Groundwater Transfer Review Summary Form

Transfer/PA # T- 13531 Re-Review

Application: T-13531 Re-Review

Applicant Name: Glenn Chowning / Port of Morrow

Figure 4. Theis Well Analysis

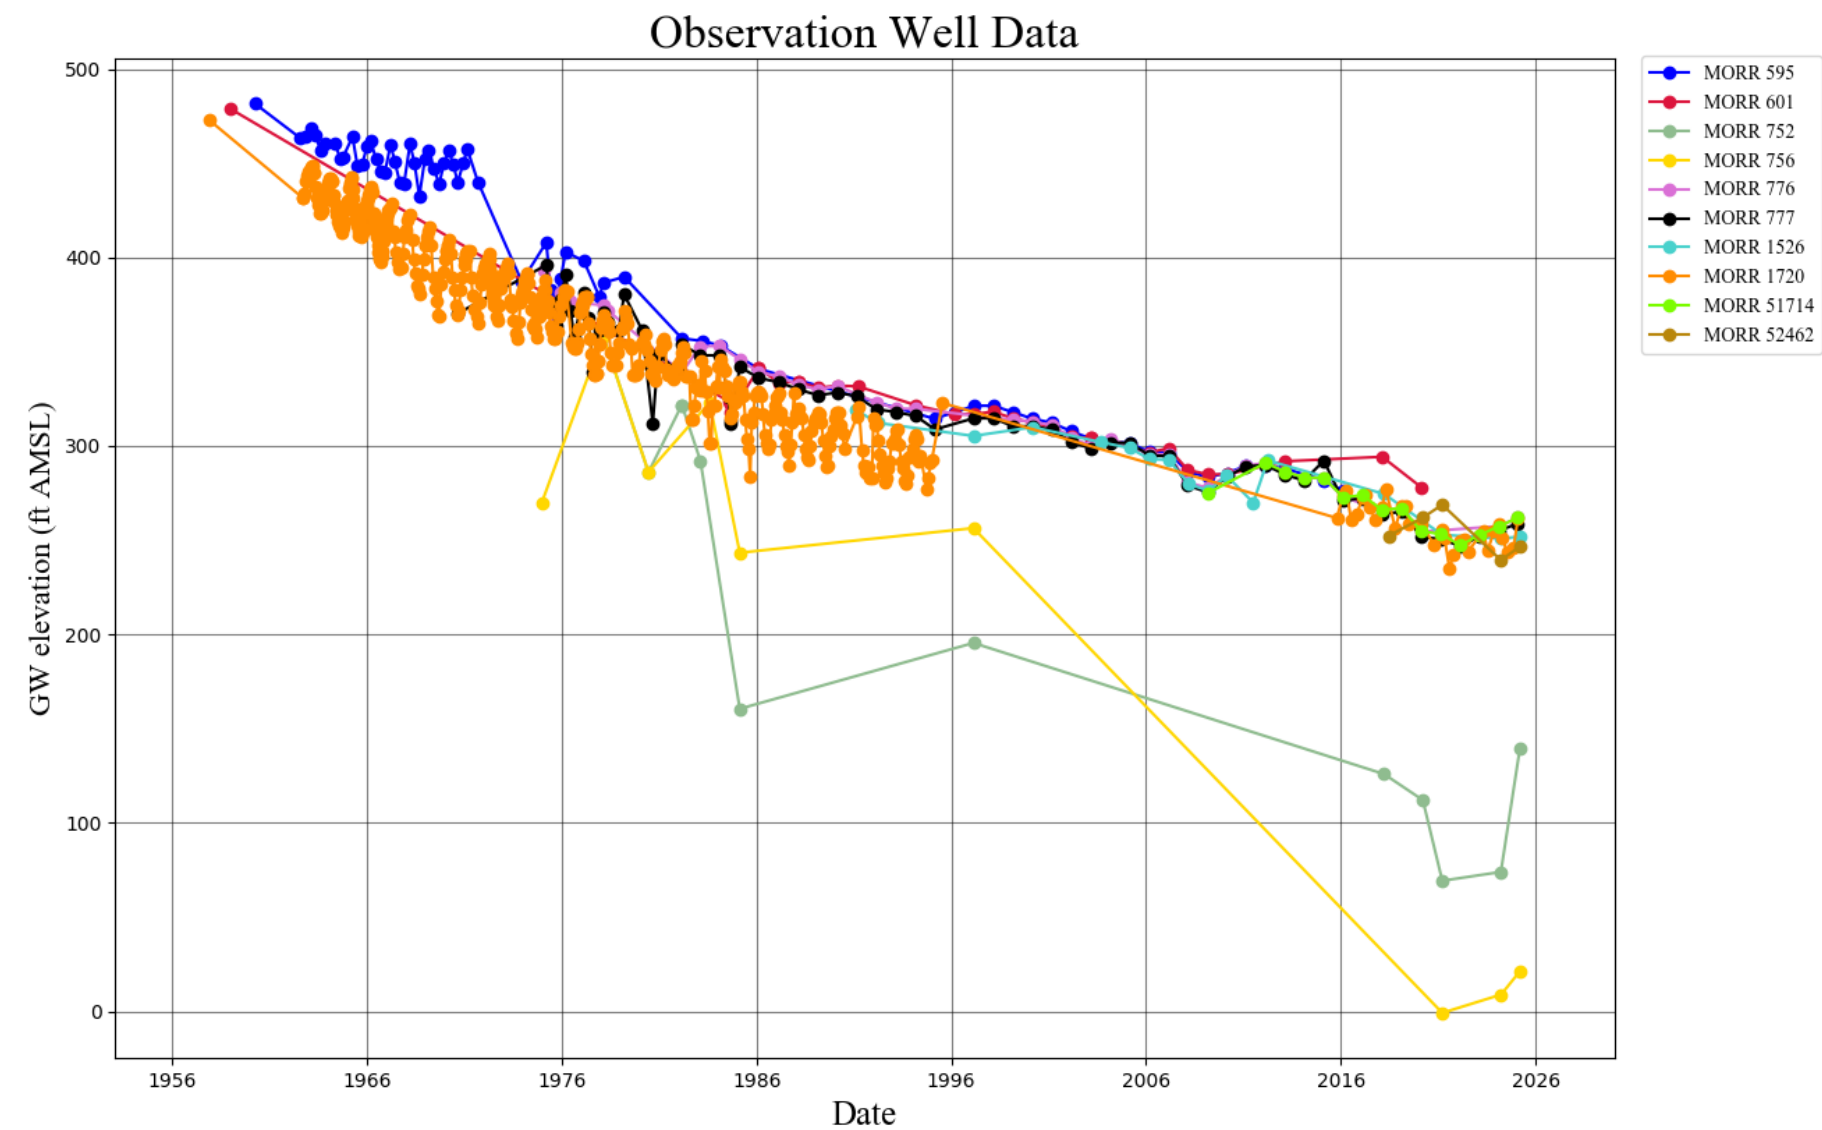
☐ Yes ☒ No If yes, explain: A Theis drawdown analysis was used to estimate interference drawdown at the nearest POA for an existing groundwater right, MORR 52462, located approximately 250 feet away from APOA MORR 1526 (see Figure 4. Theis Drawdown Analysis). The analysis was conducted assuming continuous pumping at the maximum rate of use (1.23 cfs). The applicable duty of 3 acre-ft per acre would be exhausted in approximately 121 days. Parameters for the Theis model used literature values and nearby aquifer test data including a pump test from MORR 52462. A sensitivity analysis of +/- 50% for transmissivity was used for the data range as the pump test at MORR 52462 was conducted while MORR 1526 was also pumping, suggesting the resulting transmissivity being possibly conservative to actual values.

Results of the analysis indicate that pumping at the maximum allowed rate of use from proposed APOA MORR 1526 would result in approximately 5 feet of interference drawdown at the POA for the nearest existing groundwater right (MORR 52462) for Scenario 2 in the model analysis provided below. Therefore, pumping at the maximum requested rate would likely not result in substantial or undue interference with neighboring well MORR 52462 (see attached Well Location Map and Theis Analysis).
